## ATTACHMENT VI

### POST PUBLIC NOTICE ADDENDUM: October 2011

The draft NPDES permit for the ArcelorMittal Indiana Harbor East and ArcelorMittal Indiana Harbor Long Carbon were made available for public comment from August 15, 2011, through September 30, 2011, as part of Public Notice No. 2011-8F-RD/PH. In addition, a public hearing was held in Gary, Indiana, on September 15, 2011. During the comment period and at the public hearing, comments were received concerning the draft permit. Comments received at the hearing and/or submitted via email, and this Office's corresponding responses, are summarized below. Any changes to the permit and/or fact sheet are so noted below.

**Mr. Kevin Doyle, Environmental Manager, ArcelorMittal USA LLC submitted the following comments on behalf of the permittee for the following permits: Indiana Harbor East (IN0000094) and Indiana Harbor Long Carbon (IN0063355).**

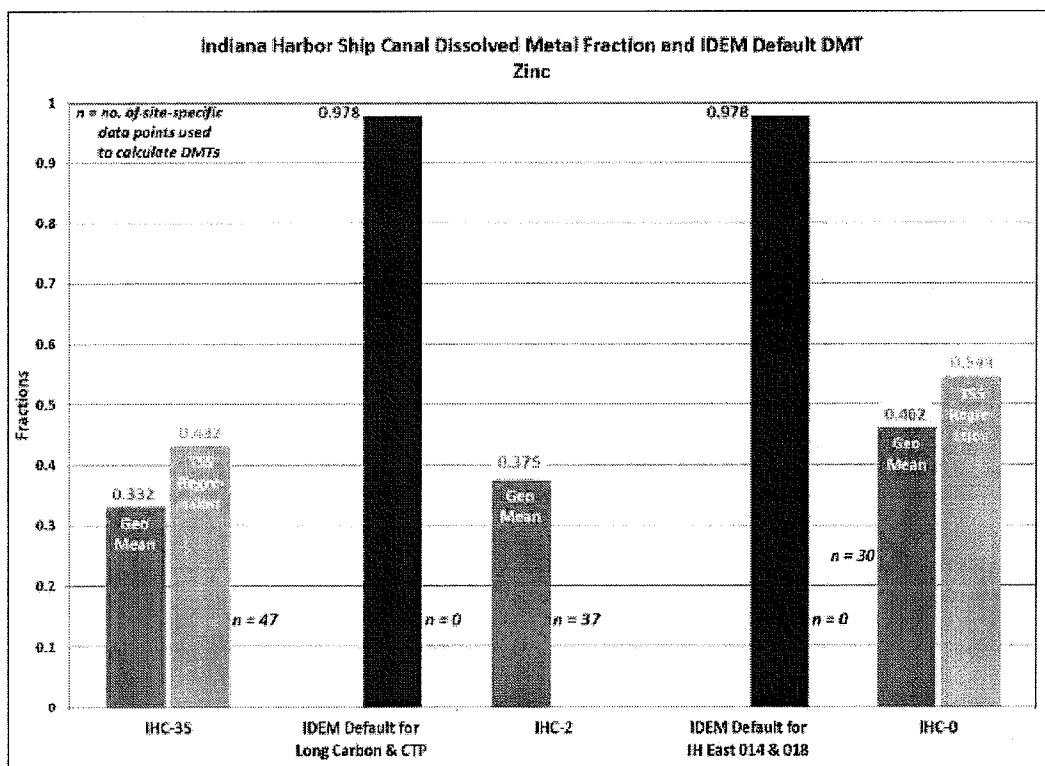
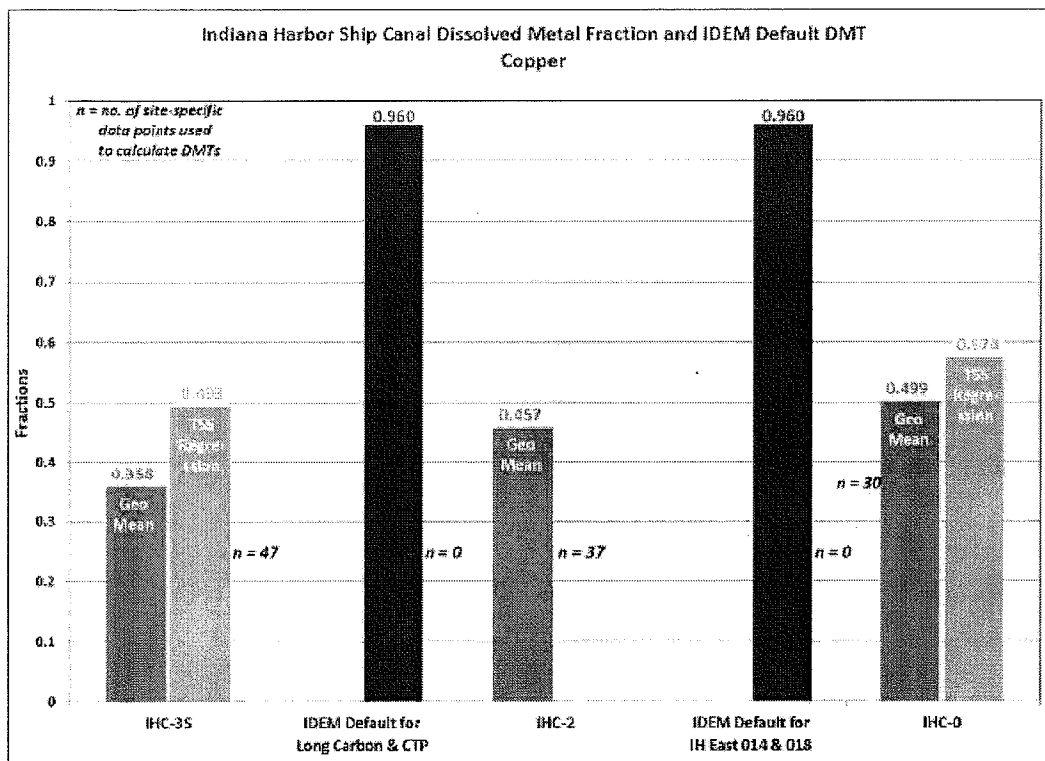
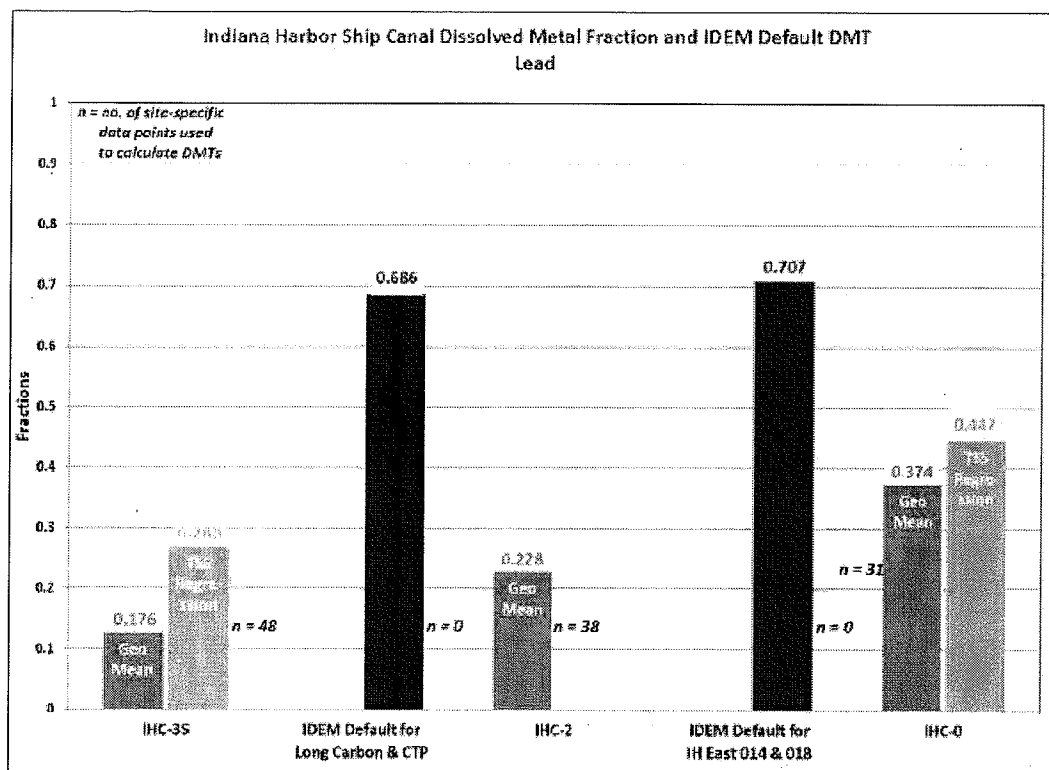
Total and dissolved data for copper, lead and zinc collected by IDEM from the Indiana Harbor Ship Canal at fixed monitoring stations IHC-2 (Dickey Road) and IHC-0 should be used to calculate site-specific dissolved metals translators (DMTs). These DMTs should be used in the calculation of preliminary water-quality based effluent limits for the Central Treatment Plant (CTP) Outfall 001, and Indiana Harbor East Outfall 014. Data collected by IDEM over a period of several years for these metals demonstrate that the majority of the copper, lead and zinc present is associated with particulate in the water column and is not in the dissolved form. Dissolved metals more closely approximate the bioavailable fraction in the water column than do total or total recoverable metals. Consequently, use of site-specific DMTs is well suited for the IHSC. The Dickey Road fixed monitoring station, located downstream of CTP Outfall 001, serves as an appropriate data set for calculating DMTs for development of WQBELs for CTP Outfall 001. IDEM should consider the Dickey Road data representative of conditions in the IHSC and reliable because IDEM used the lead and zinc data collected at Dickey Road for another purpose in

the NPDES permit renewal process for the ArcelorMittal facilities (*i.e.*, Dickey Road data were used to project the effluent quality from Indiana Harbor West Outfall 007 in IDEM's multi-discharger WLA). The IHC-0 fixed monitoring station is located downstream of Indiana Harbor East Outfall 014.

Per EPA guidance<sup>2</sup>, DMTs can be calculated as the dissolved to total metal fraction, and can be calculated from a correlation of the dissolved fraction to receiving stream TSS concentration. Following that guidance, DMTs for copper, lead and zinc were calculated from the Dickey Road and IHC-0 data and are summarized below. The dissolved and total metals data used in the DMT calculations are attached (see Attachment IHC-1). For comparison, IDEM's default translators that were used in the development of the proposed permit limits, and DMT's calculated from data collected by IDEM at fixed Station IHC-3S are also shown.

As noted in a prior response, IDEM does not believe it is acceptable to re-establish background at Dickey Road and has not received a site-specific metals translator study so the current multi-discharger model was not revised. IDEM did look at the impact of lowering the ArcelorMittal Long Carbon allocation, as requested, and did not find a significant impact on the calculation of downstream WQBELs. For future wasteload allocation considerations, a site-specific metals translator along with more refined effluent concentration characteristics will provide the greatest means of showing that more assimilative capacity is available than currently modeled.
